HORSHAM DISTRICT COUNCIL CONSULTATION

TO:	Horsham District Council – Planning Dept
LOCATION:	Land North of East Street Ruster West Sussex
DESCRIPTION:	Erection of 18no. 2, 3 and 4 bedroom dwellings, (including 6no. affordable housing units), together with access from East Street, vehicle and cycle parking, landscaping and open space, and sustainable drainage.
REFERENCE:	DC/25/0523
RECOMMENDATION:	Holding Objection / Modification

Photographs showing T22 limb removal above the bat PRF-M.

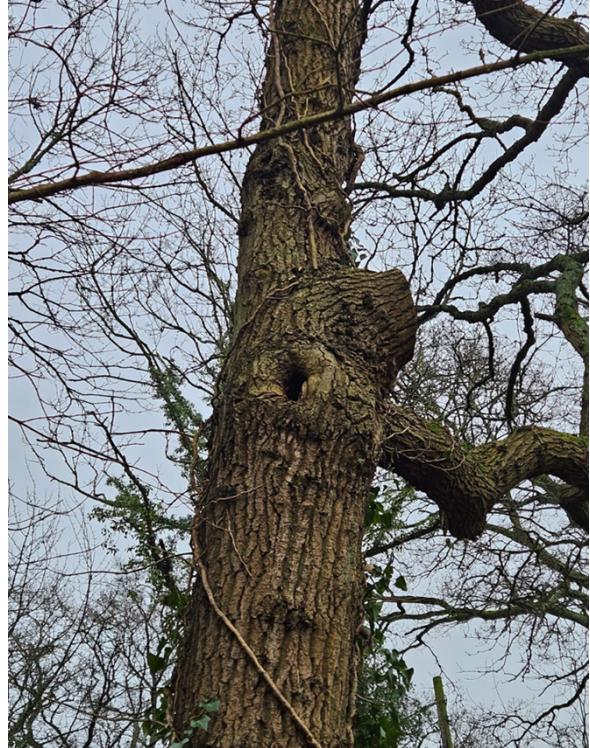
One of the trees (T22) along the southern boundary has a single PRF-M (Potential Roosting Feature – Maternity), a rot hole on a major limb on the south-western aspect of the tree approximately 4m above ground level. This appeared to lead into a small cavity within the limb (Para 3.14 of the PEA, Ecology Partnership, Jan 2025). Para 4.10 states that as this tree is to be retained, no further survey will be necessary. However, Para 4.11 goes on to say that the tree should be protected during construction.

It is disappointing that current works to date (January 2025) have involved limb removal of the tree, exposing the PRF and as a result potentially changing the microclimate of the roost feature. If these works were communicated with the ecologists, it is likely that further survey would have been strongly advised. In the absence of any evidence to suggest bats are not using this roost for whatever purpose, it cannot be ruled out that an offence under the Conservation of Habitats and Species Regulations 2017 may have been committed.

No further works should be undertaken on site without seeking ecological advice. Given the impacted PRF is that for multiple bats (potential maternity (+) value), it is expected that compensation be provided through provision of multiple bat boxes, that cater for both day/night/transitional roosts and maternity/hibernation roosts. This should be forthcoming in a Biodiversity Enhancement Strategy and should also include the recommended artificial house sparrow and swift nest boxes and log piles, as per Paras 4.25-4.29 of the PEA. The locations of these should be annotated on landscaping plans.
